The Sizewell C Project, Ref. EN010012

Comments on any additional information/submissions received at D6 and D5

Suffolk County Council Registration ID Number: 20026012

APPENDIX 1: SCC COMMENTS ON SCHEDULE 14 OF DRAFT DCO REVISION 6.0 [REP6-006]

Lovers Lane

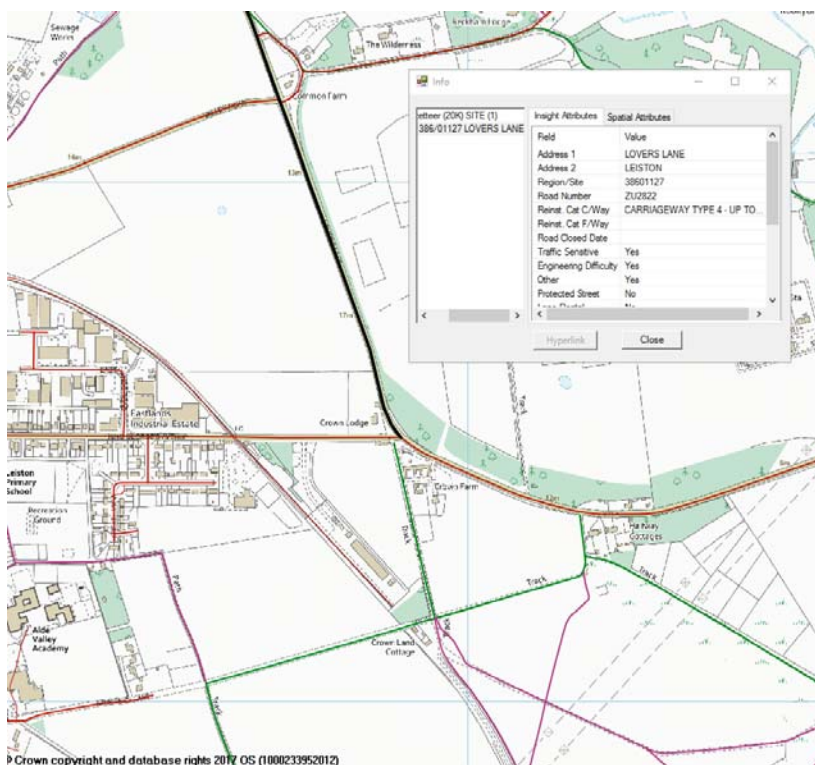
The extents of the speed limit are not practical as Lovers Lane does not extend east of King George Avenue. For the temporary speed restriction, it is not clear how two speed limits on the same stretch of road will be implemented and removed so that there is no overlap. For Lovers Lane, there are 5 temporary speed restrictions included. If the duration of the temporary speed restriction extends beyond 18 months then this needs to be clearly stated (with duration)

Main development site and rail	Hawthorn Road	From the The Green junction to 600m north of The Green junction	30mph speed restriction
Main development	Hawthorn Road	From the Hawthorn	30mph speed

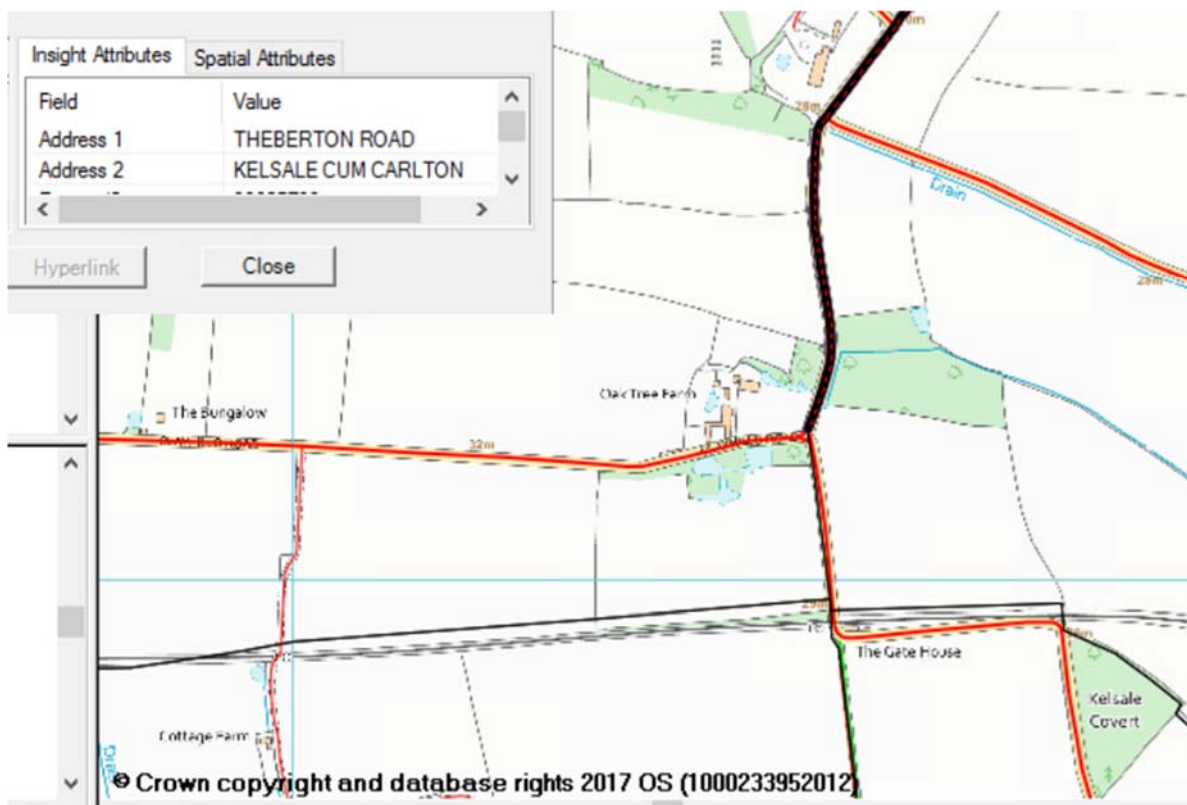
Part of what is described in the schedule as Hawthorn Road is in the street gazetteer as Theberton Road.

Main development site and rail	Unnamed road running north from Hawthorn Road	From the Hawthorn Road junction to 100m north of the Hawthorn Road junction	30mph speed restriction
--------------------------------	---	---	-------------------------

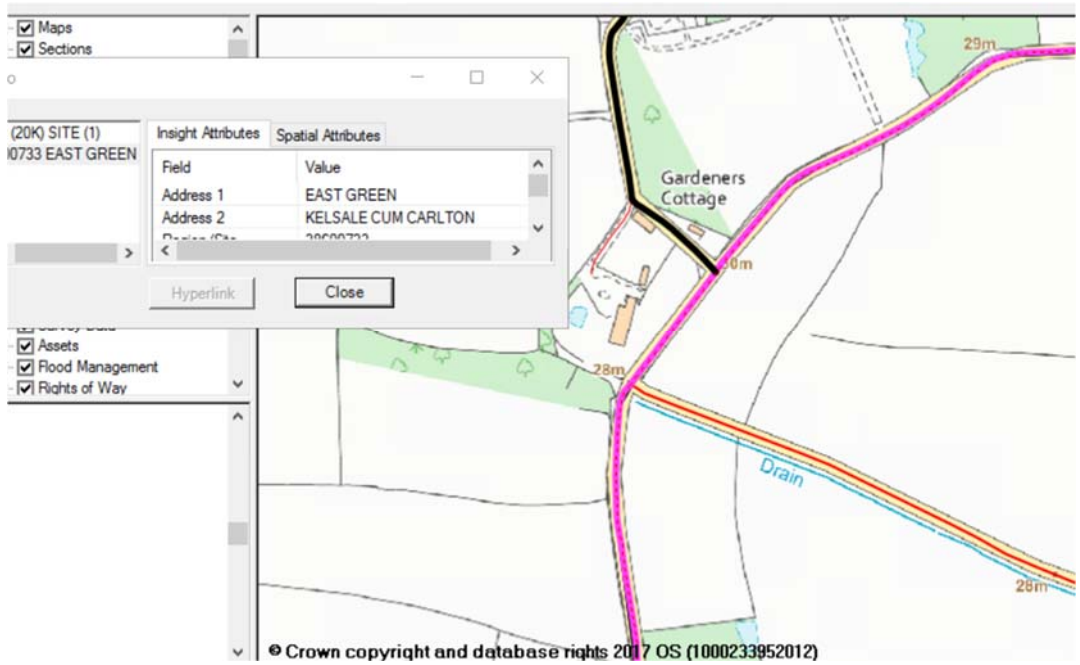
This description is ambiguous and does not identify the road. It is presumed to be East Green, Kelsale cum Carlton and Hawthorn Road should again be Theberton Road.

Two village bypass	Unnamed road north of A12, opposite Tinker Brook]	From the A12 junction to 800m north of the A12 junction	30mph speed restriction
--------------------	---	---	-------------------------

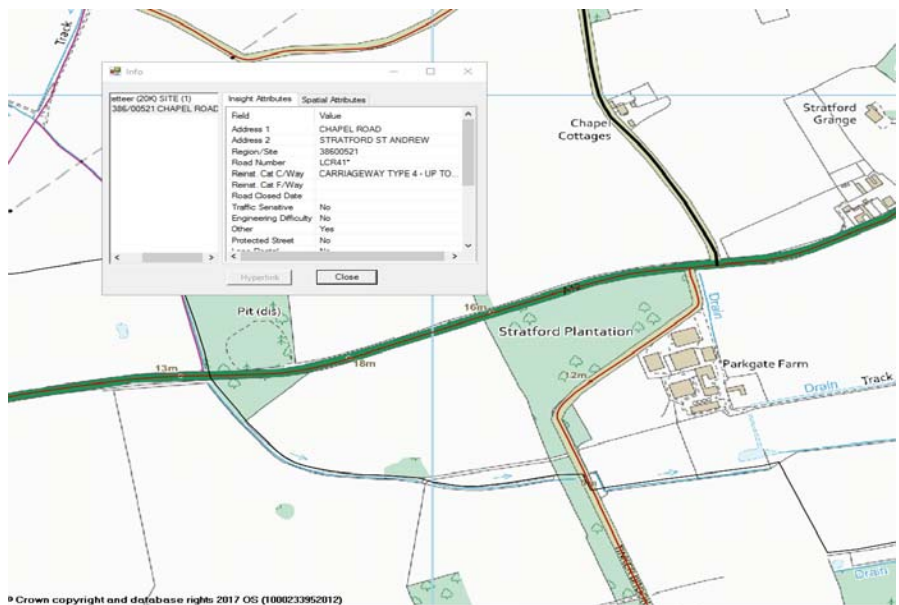
The unnamed road opposite Tinkers Brook is Chapel Road

Freight management facility	Levington Road	Entire length (between Felixstowe Road and the end of the road to the south of the A14)	30mph speed restriction
-----------------------------	----------------	---	-------------------------

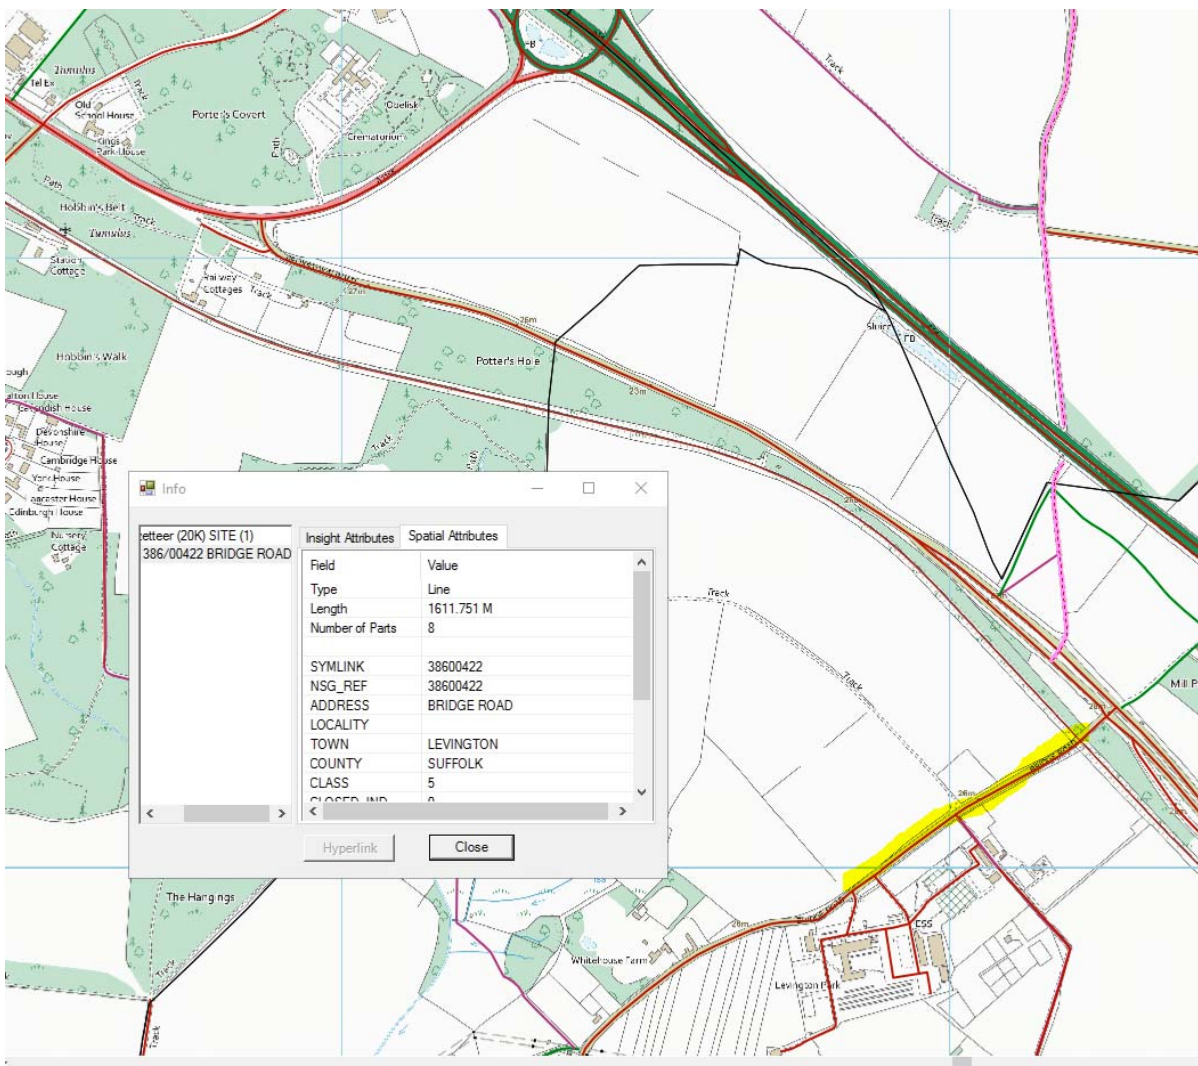
Levington Lane (pink) is north of the Bridge Road junction (yellow) so it is confusing to refer to 'Felixstowe Road north of Levington Lane'

And Levington Road is Levington Lane

Sizewell link road	Onner's Lane	From the B1122 junction to 350m north of the B1122 junction (for Moat Road works); and From the B1122 junction to 800m north of the B1122 junction	30mph speed restriction
--------------------	--------------	--	-------------------------

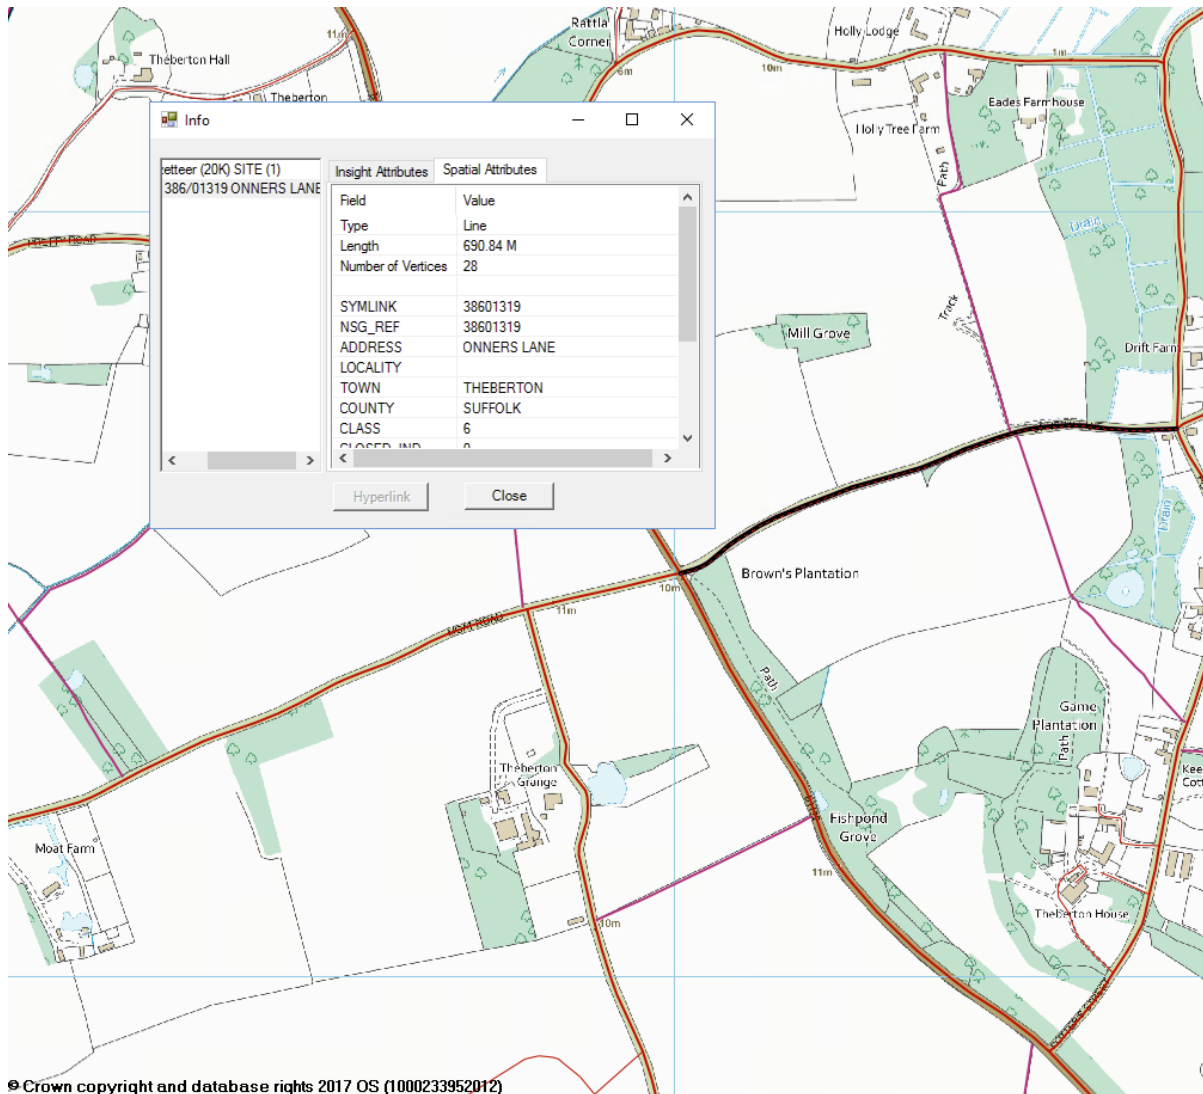
Onners Lane is only 680m in length.
